MAEC TECHNICAL NEWS

No. M16C-86-0205

M16C/80, M32C/82 and M32C/83 Groups

Usage Precaution on Three-phase Motor Control Timers' Function

Figure 1. An example of output waveform when writing to Timer Ai-1 register near Timer B2's overflow

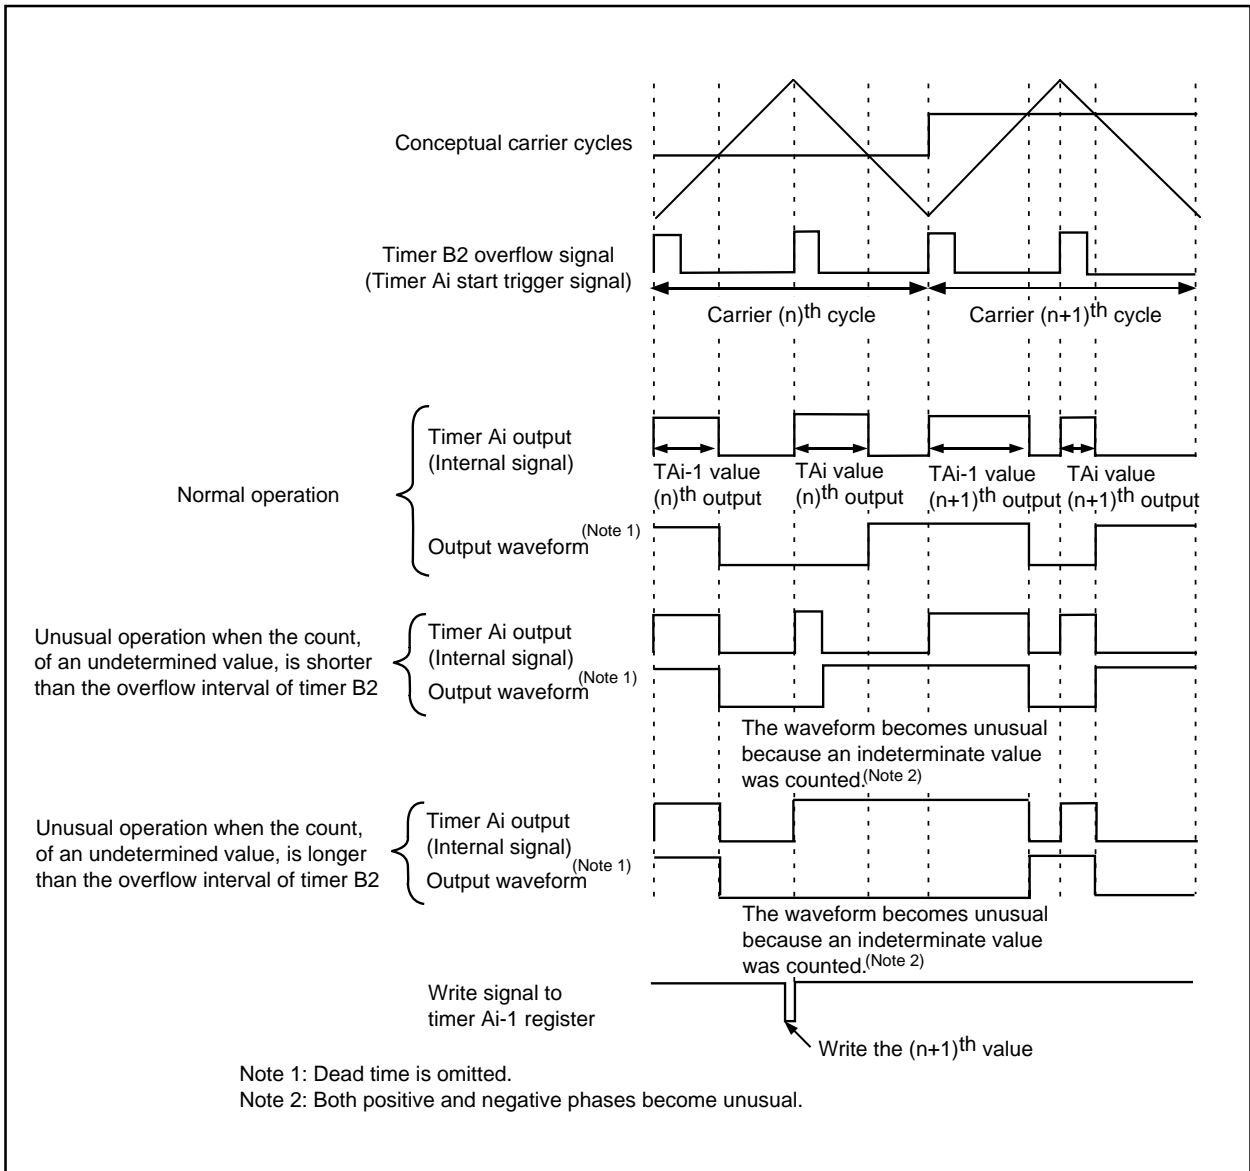
While using the timers in Three-Phase Mode 1 for Three-Phase Motor Controls and near Timer B2's overflow, if a count value is written to Timer Ai-1 register ($i=1, 2, 4$), a different count value may be written to Timer Ai instead of the value you want to set it to. This will then cause a different output waveform.

Figure 1 shows an example of output waveform when writing count value to Timer Ai-1 register near Timer B2' overflow and Figure 2 shows the write timing to Timer Ai-1 register when the output waveform is unusual.
